SR 360 WIDENING
CSSTP-0006-00(049) - P.I. No. 0006049
Cobb and Paulding Counties, Georgia

Value Engineering Study Report
Preliminary Design Stage

re: Project No. CSSTP-0006-00(049), P.I. #0006049
Widening of SR 120/Charles Hardy Parkway to SR 176/Lost Mountain Road
Value Engineering Study Report

ALTERNATIVE No.
P-9
SHEET 2 OF 7

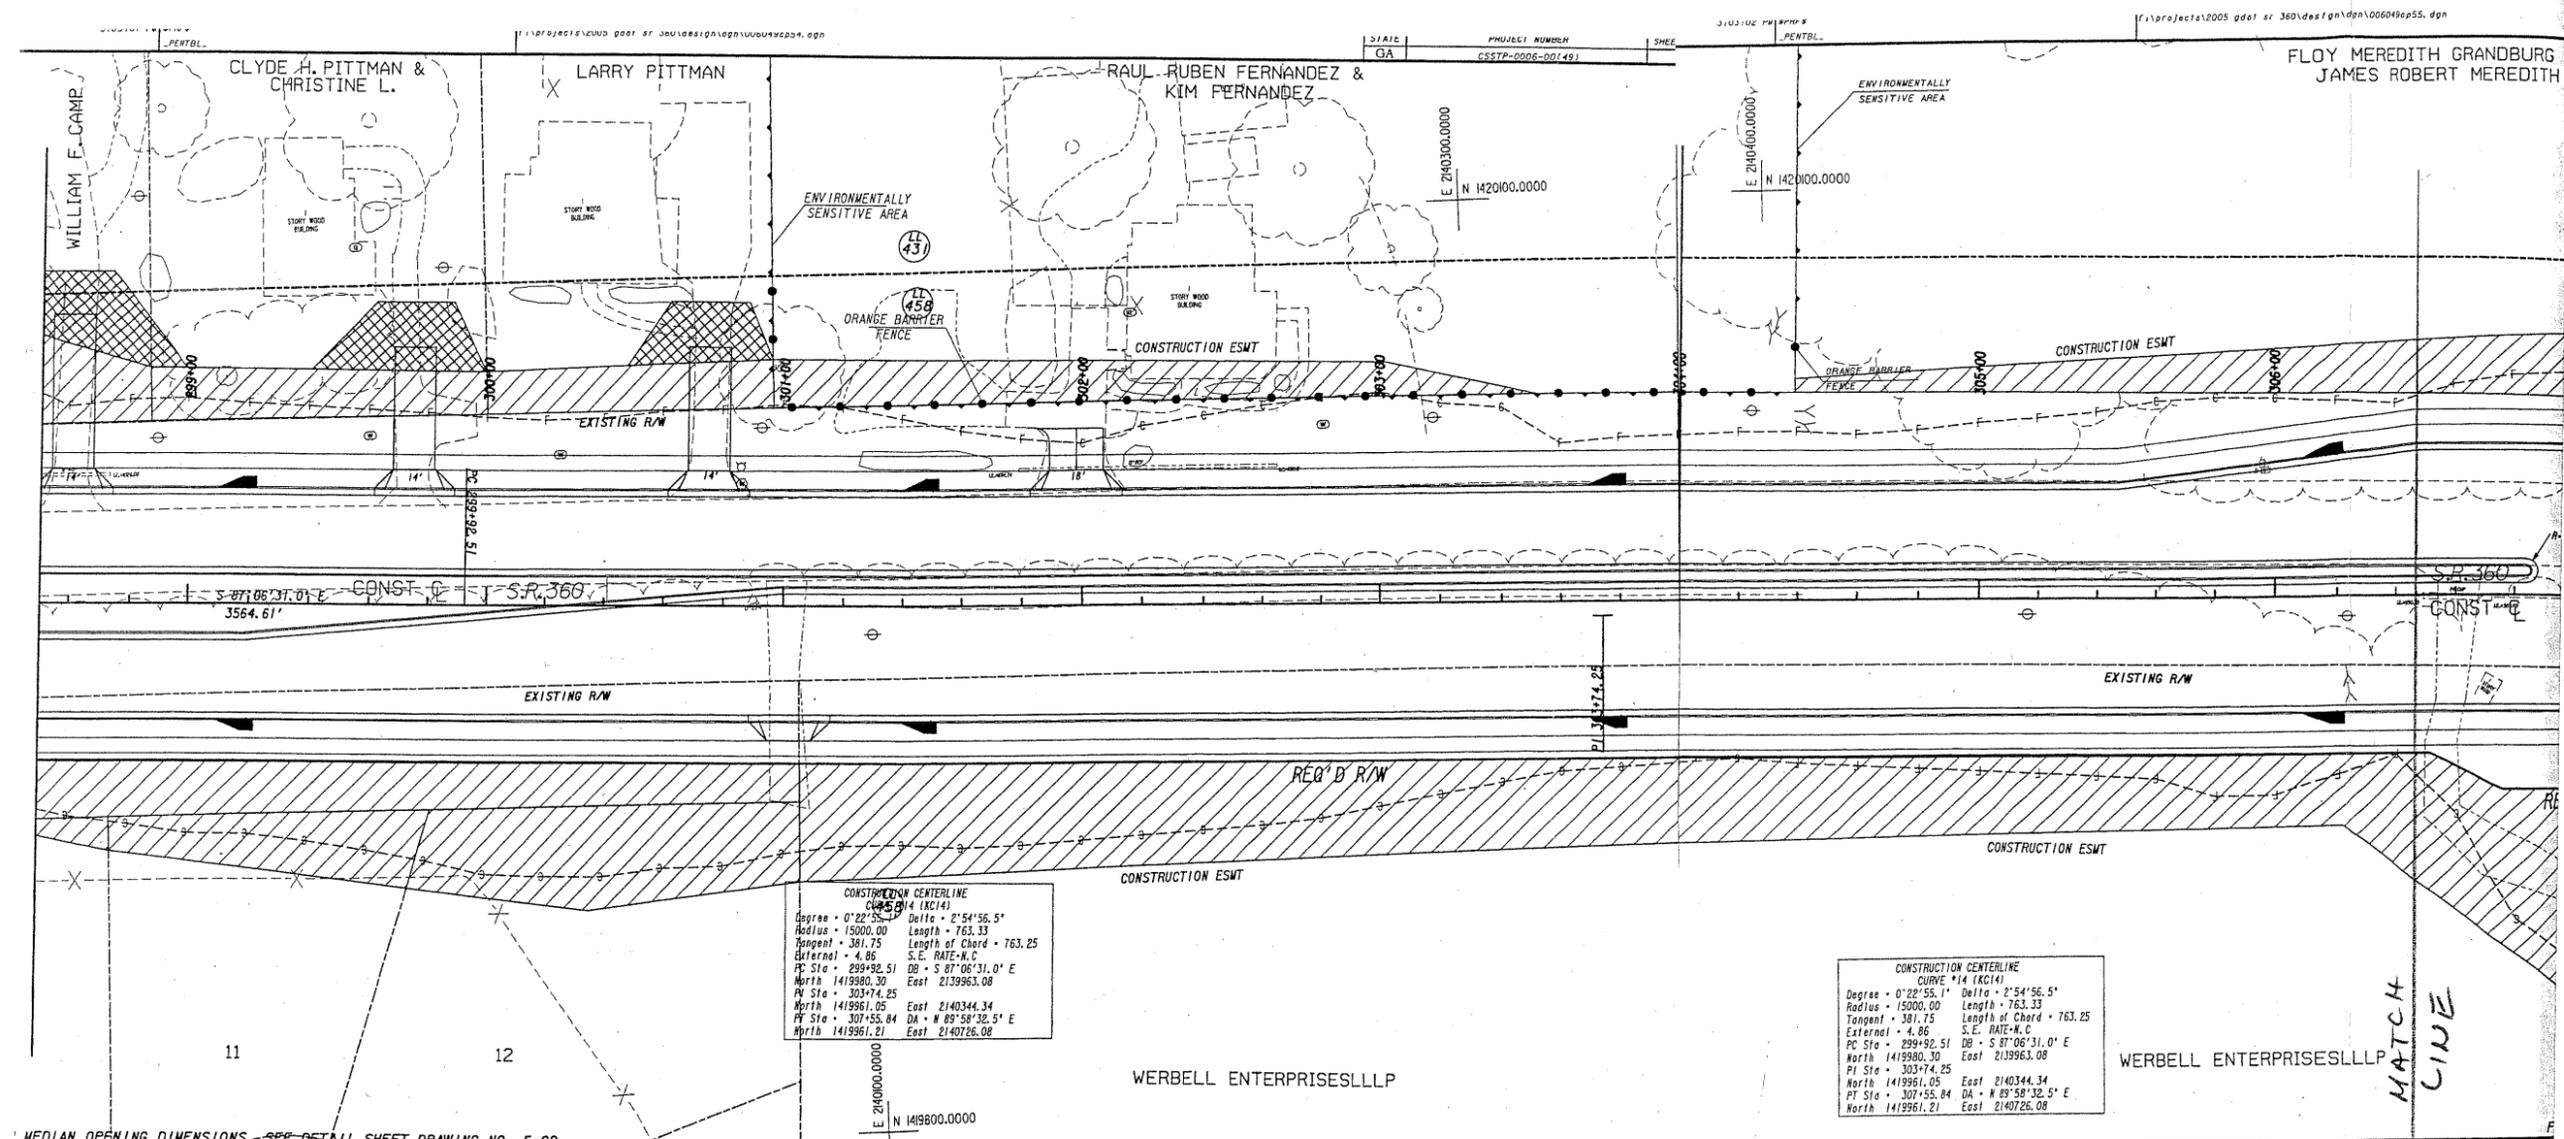
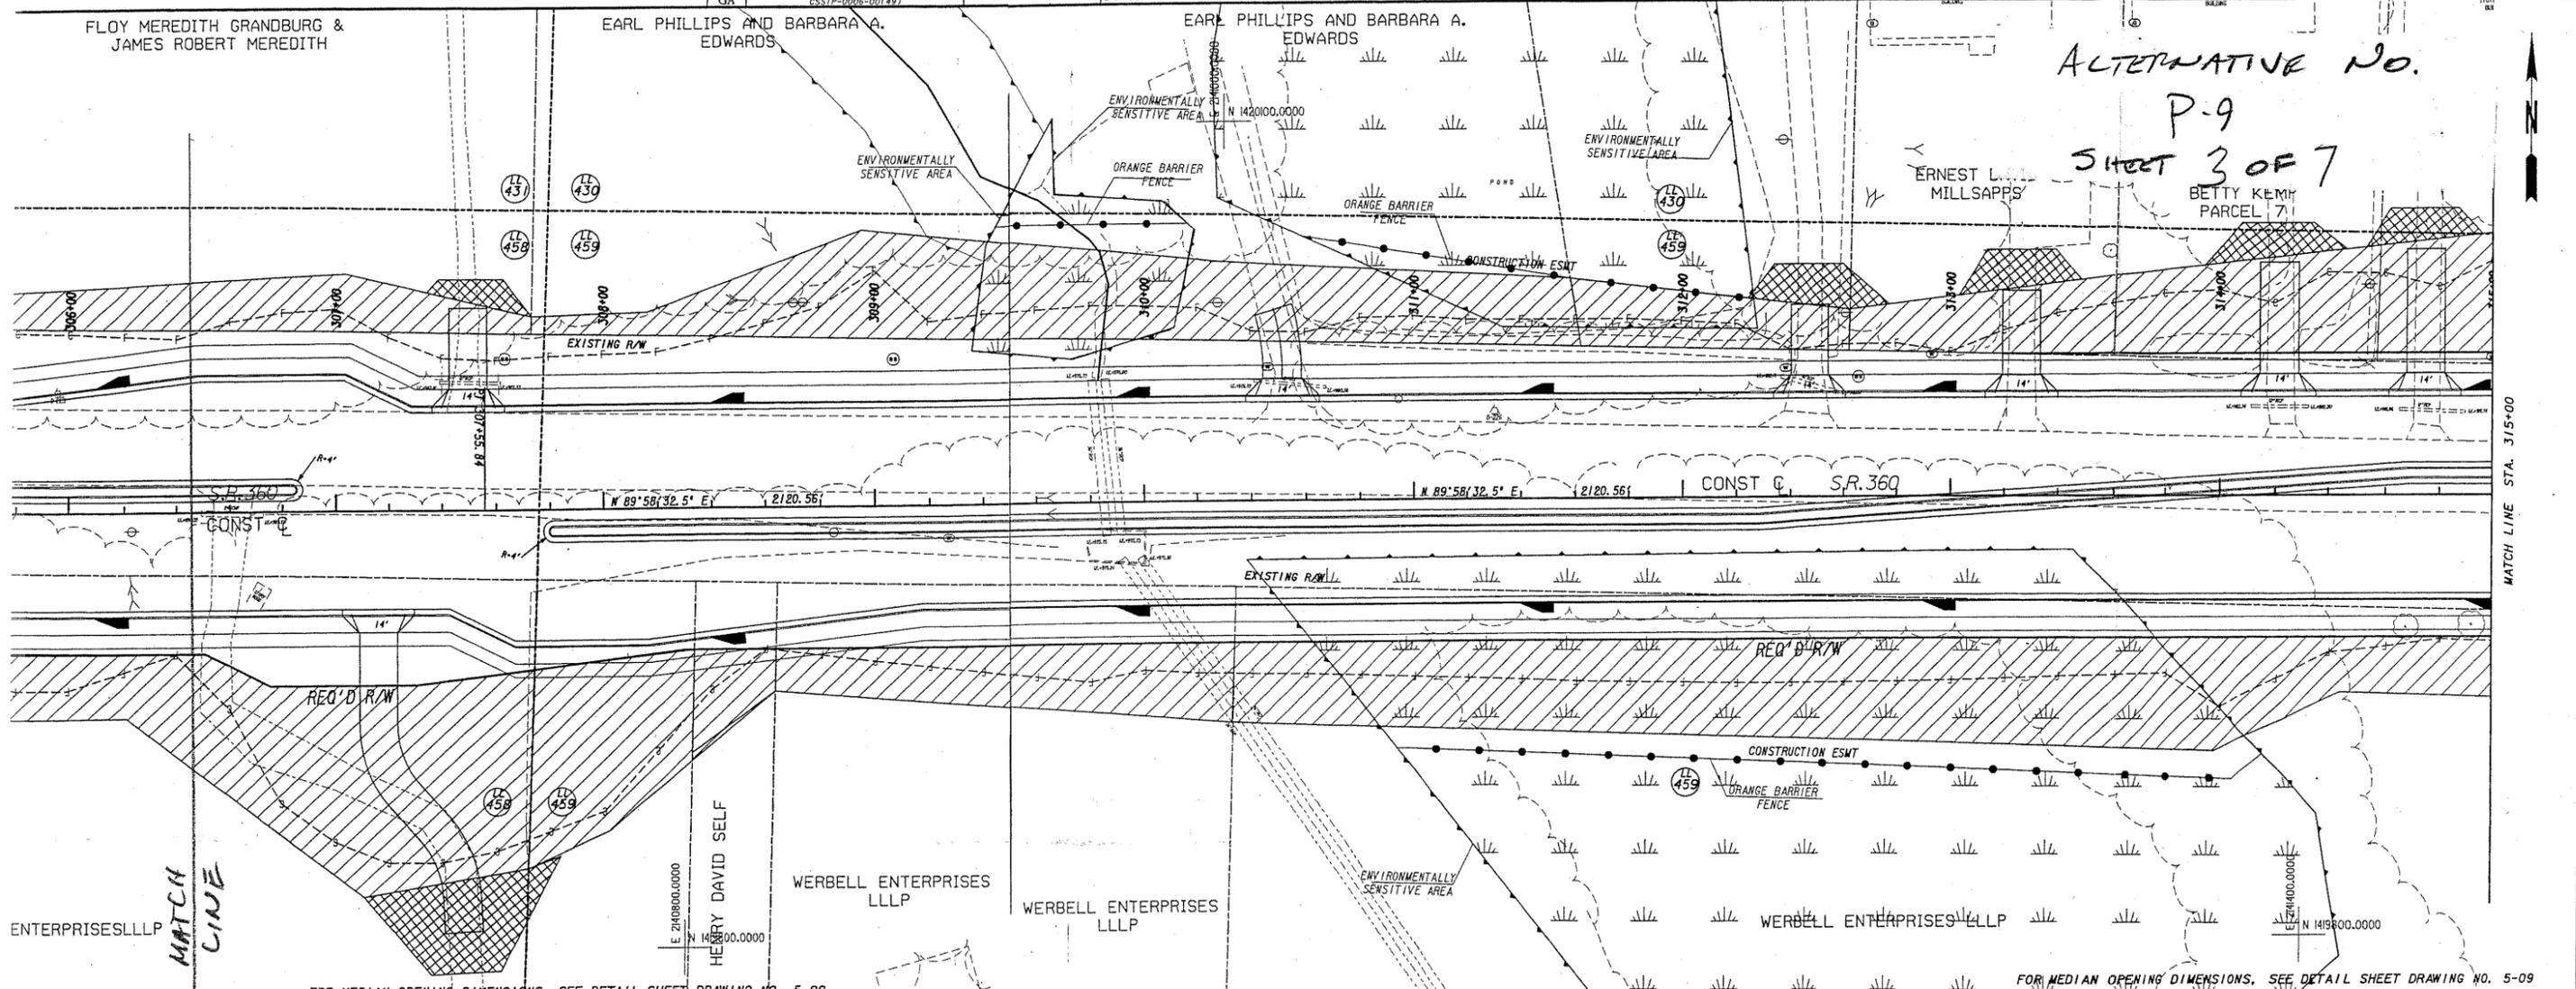
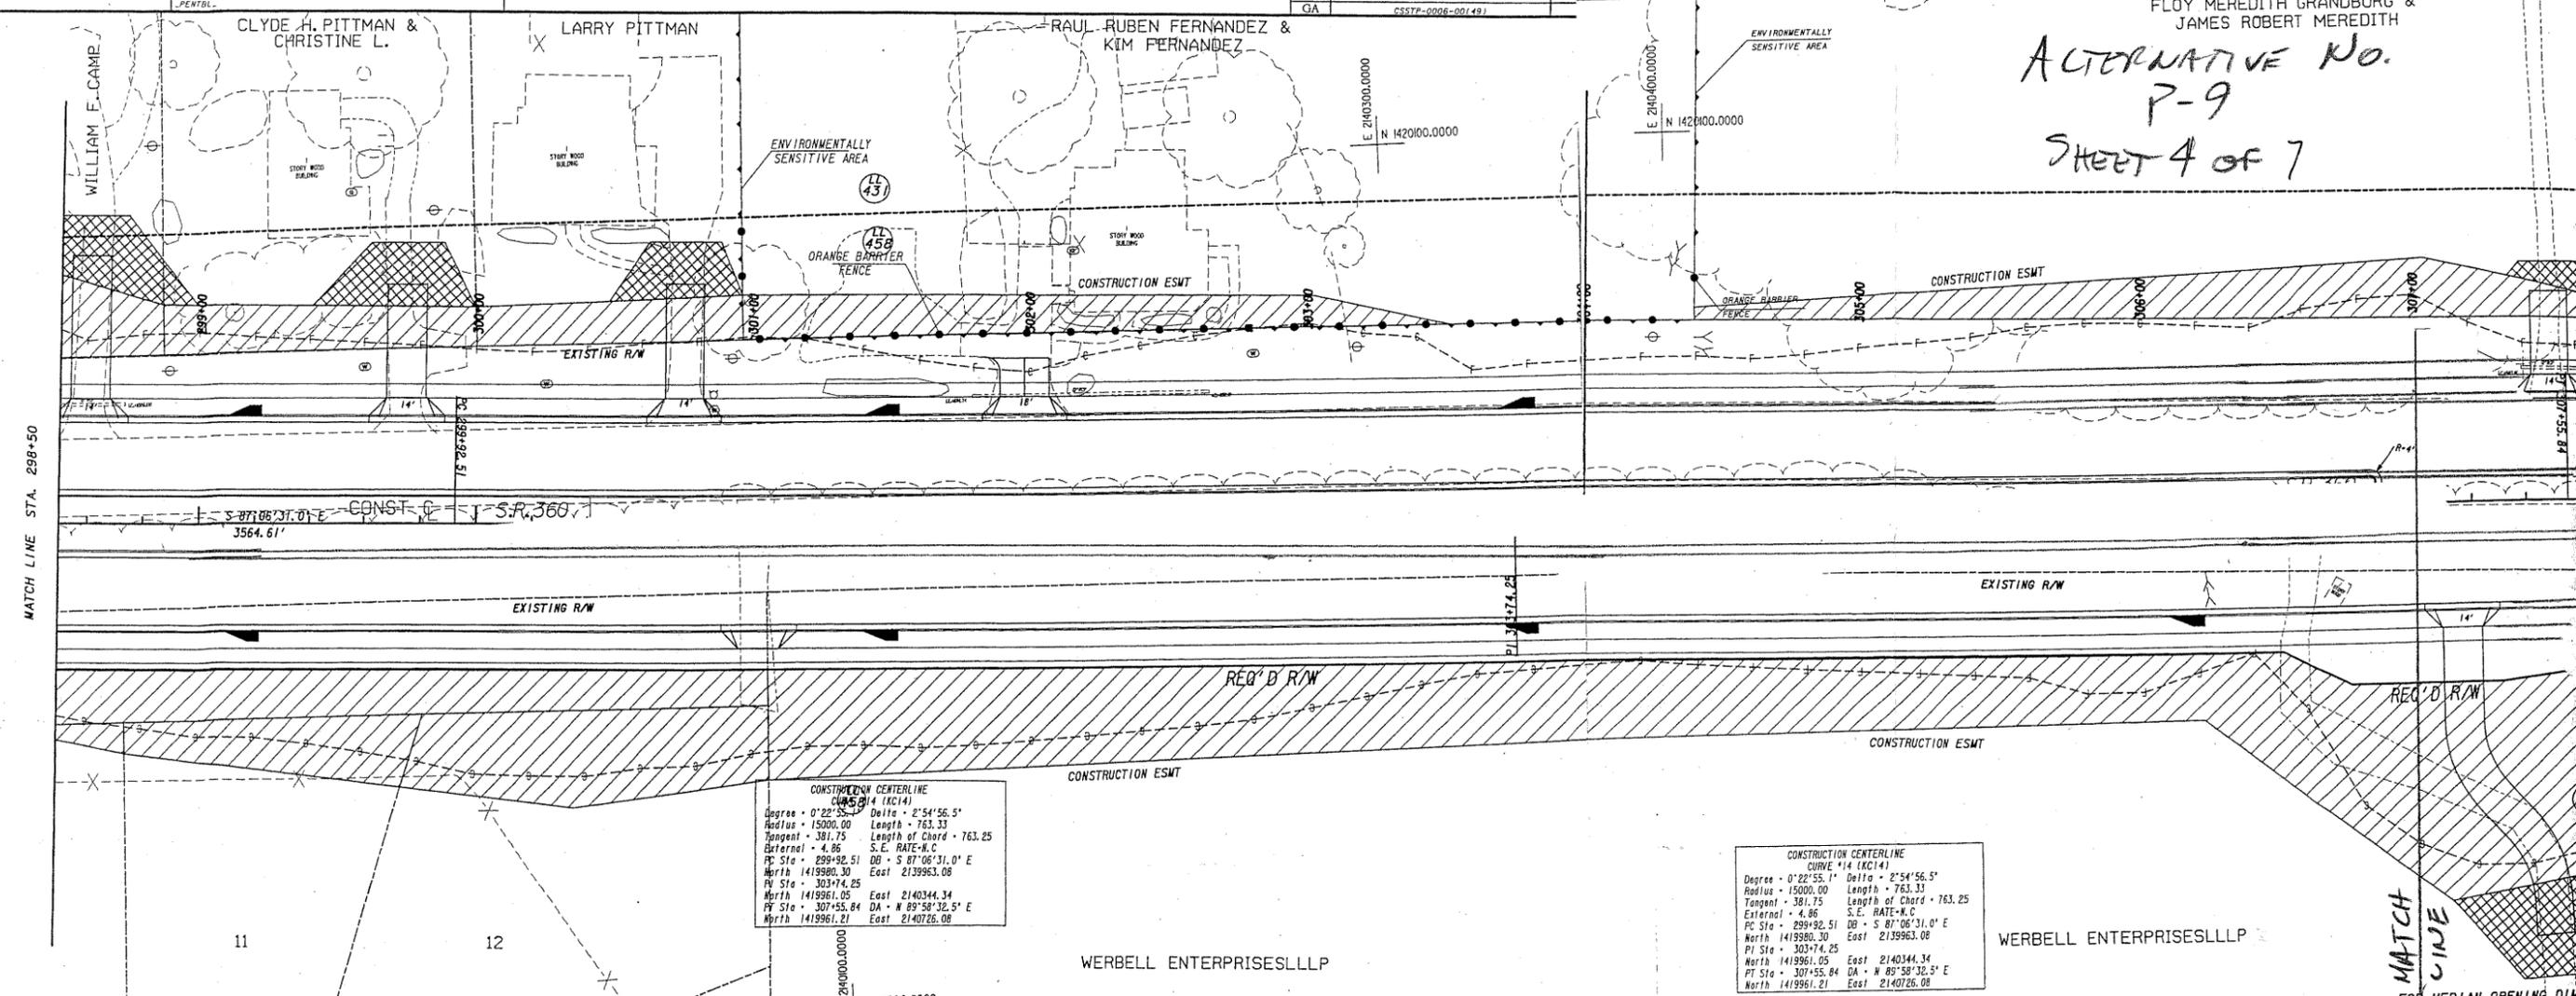
DESCRIPTION: **REMOVE U-TURN AT STATION 307+50**

Delete the U-turn at Station 307+50.
